SUBJECT: Complaint Investigation, Complaint No. 33602, Staff Action No. 175731, Adair County

Report of Investigation

RE: Complaint Investigation, Complaint No. 33602, Staff Action No. 175731, Adair County

Figure #3: West basin with area of concern and direction of flow

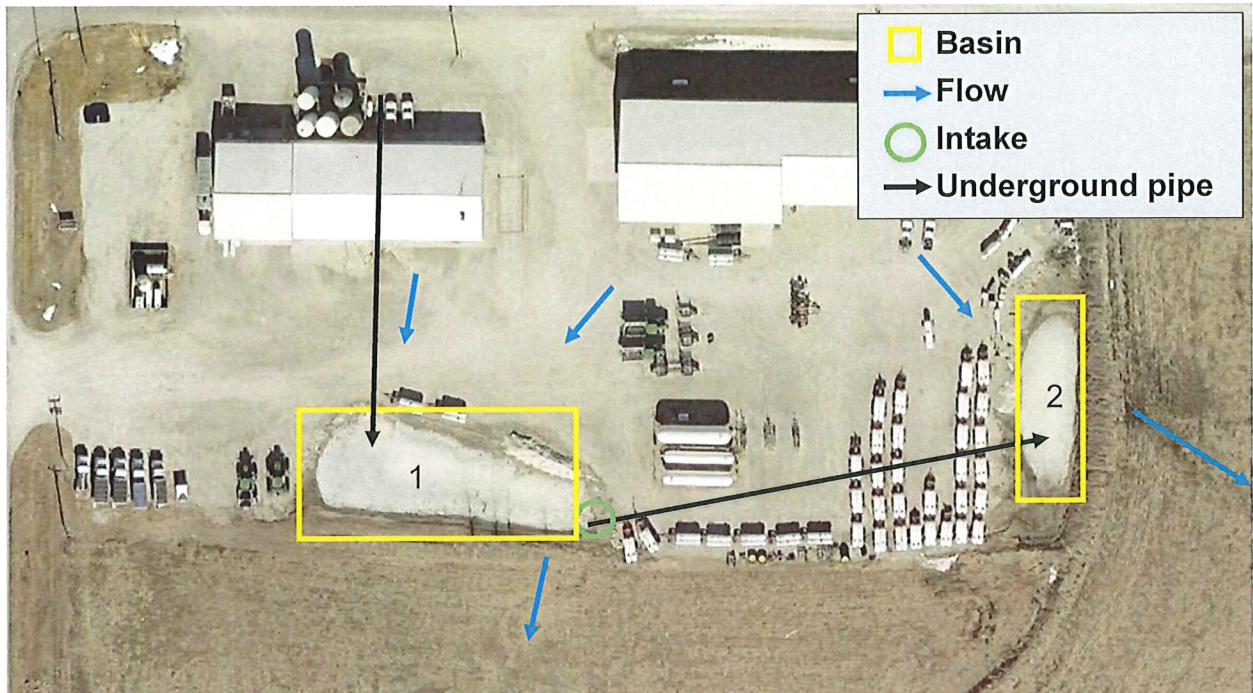
While no water quality violations were noted, there are deficiencies in stormwater controls at your site. It appears as though the western basin has overflowed at some point. Additionally, the intake associated with the basin appears to have been designed as a managed intake with a cap over the pipe to regulate when flow to the secondary basin can occur. At the time of our inspection the cap was present but water was actively flowing around the cap and through the tile to the second basin. This should be modified so no further flow can occur without active management. Also, please evaluate the elevation of the intake pipe to ensure it is placed at the correct grade. This will help ensure the basin does not overflow the berms.

We observed several empty chemical totes located around the western retention basin and the water was green in color. A stormwater inlet pipe is located on the northern side of the basin and was not flowing at the time of this investigation. On the southern berm of the basin we located an area of dead grass from the top to the bottom of the berm. Within the area of dead grass were signs of some trenching and erosion indicating the potential for the basin to overflow or evidence that it has overflowed before. Liquid levels were not at the high-water mark at this time. The photos below document the western basin.

Please ensure repairs to the basins are made, including a plan for dewatering the eastern most basin. Please contact me by **July 15, 2024**, documenting repairs were made.

Figure #4: Eastern basin with areas of concern and direction of flow

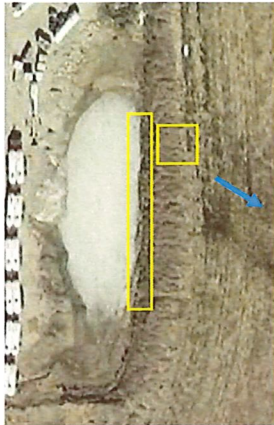
The east retention basin is designed to be dewatered when needed. However, although the area has received 9 inches of precipitation during the course of the last 3 months, Mr. Miller stated he has never needed to dewater the basin. During this investigation we observed signs of trenching indicating that the basin has overflowed. Measures must be taken to ensure an overflow does not occur. Additionally, the basin has several animal burrows on the east and west side of the berm. These should be filled to ensure a berm failure does not occur.

We then inspected the eastern basin. We observed green water flowing through the tube from the west basin. On the eastern berm several animal burrows were noted on the west side of the berm itself and near the waterline of the berm. On the east side of the berm holes were again noted in the berm wall and an area of flow appeared to be coming out of one of the holes but was not flowing at this time. This basin is not equipped with a tile line to discharge the basin and must physically be dewatered. However, evidence that the basin had overflowed was observed. We took another field test and noted ammonia levels of ≈ 250 mg/L. The photos below document the eastern basin.
